Access Compliance Report

Public Rights-of-Way

(Pedestrian Signals)

Intersection ID: N/A	Main Street:	Cross Street: N/A	Location: N/A
ADA ID: E6A41629B7C7	Signal Type: One Push Button-Non APS	Overall Compliance: No	Severity Score: BTN 1: N/A BTN 2: N/A No BTN: N/A
Codes/Mitigation Info/Possible Solution		Field Measurements/Component Compliance

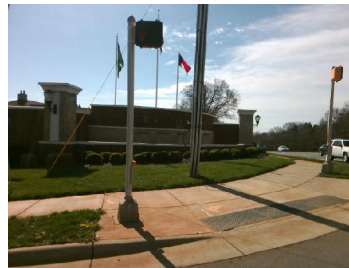
PROW/ADA: R404.2, R404.7.2

N/A	B 1 FWD Approach Width (in)	N/A	N/A	B 2 FWD Approach Width (in)	N/A
N/A	B 1 FWD Approach Obstruction?	Yes	N/A	B 2 FWD Approach Obstruction?	N/A
N/A	B 1 FWD Approach Obstruction Dist (in)	2.0	N/A	B 2 FWD Approach ObstructionDist (in)	N/A
N/A	B 1 PARA Approach?	Yes	N/A	B 2 PARA Approach?	N/A
N/A	B 1 PARA Approach Constrained?	Yes	N/A	B 2 PARA Approach Constrained?	N/A
Yes	B 1 PARA Approach Reach (in)	4.0	N/A	B 2 PARA Approach Reach (in)	N/A
No	B 1 PARA Approach Width (in)	48.0	N/A	B 2 PARA Approach Width (in)	N/A
N/A	B 1 PARA Approach Obstruction?	Yes	N/A	B 2 PARA Approach Obstruction?	N/A
N/A	B 1 PARA Approach Obstruction Dist (in)	1.0	N/A	B 2 PARA Approach ObstructionDist (in)	N/A
Yes	B 1 Clear Floor Space Slope (%)	1.5	N/A	B 2 Clear Floor Space Slope (%)	N/A
No	B 1 Clear Floor Space XSlope (%)	2.5	N/A	B 2 Clear Floor Space XSlope (%)	N/A
N/A	B 1 PAR Slope (%)	N/A	N/A	B 2 PAR Slope (%)	N/A
Yes	B 1 Height (in)	37.0	N/A	B 2 Height (in)	N/A

Possible Solutions: Remove and Replace Clear Space.
